Docket Item #16
DEVELOPMENT SITE PLAN #2002-0022
TUSCANY CONDOMINIUMS-YOAKUM PARKWAY

Planning Commission Meeting
September 9, 2004

ISSUE: Consideration of a request for a development site plan for construction of a multi-family residential condominium development.

Tandem Spaces in Gray

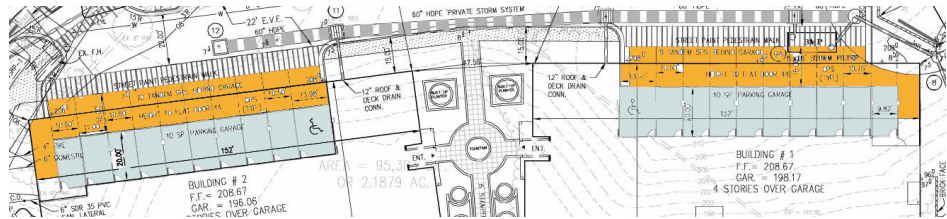
Staff’s primary concern remains with the inadequacy of proposed parking and the potential impacts of overflow parking onto adjoining properties as well as within the site. Staff is concerned that visitors will illegally park in the proposed drive aisle on the eastern portion of the site which also serves as an emergency vehicle easement. Topography limits fire truck access to the western (Yoakum Parkway) and the eastern portion of the building. Therefore, illegal visitor parking within the emergency vehicle easement will significantly impair the emergency and fire access to the building. In addition, residents would also likely illegally park on the adjoining Yoakum Parkway, impacting the traffic and vehicle safety of the adjoining streets. Compounding the concern regarding parking is the fact that 60% of the total proposed spaces are compact spaces (except for the tandem and handicap spaces).

Staff believes the arrangement of parking facilities on the site will, in fact, create a parking problem within the complex.

The applicant contends that visitor parking is not required by the Zoning Ordinance and therefore should not be a condition to approve this site plan. However, Sections 11-410 (C)(D)(E)(K) (L) of the Zoning Ordinance all reference the need to ensure adequate and reasonable provision for parking spaces and adequate fire access, and to ensure that elements within the site plan do not create hazards to vehicles, pedestrians, fire access or traffic. As discussed above, staff believes the inadequacy of visitor parking spaces will negatively impact fire access to the building and traffic on the adjoining street and, therefore, recommends that the applicant provide 15% non-tandem visitor parking spaces.

Staff believes the only reasonable alternative is to provide 15% visitor parking to meet the demand of the proposed facility and visitors. While it is acknowledged that a small percentage of the tandem spaces could be used by visitors, this should be a very limited amount and the applicant should provide the 15 % recommended by staff.

4. The applicant shall provide 15% visitor parking excluding tandem spaces. The location and design of the spaces shall be revised prior to the release of the final site plan to the satisfaction of the Director of P&Z. The applicant shall install "Visitor Parking Only" signs for all visitor parking spaces. A minimum of one space for each unit shall be provided within the garage as part of the purchase price for each unit. The underground parking shall have controlled access. (P&Z)(T&ES)(Police)
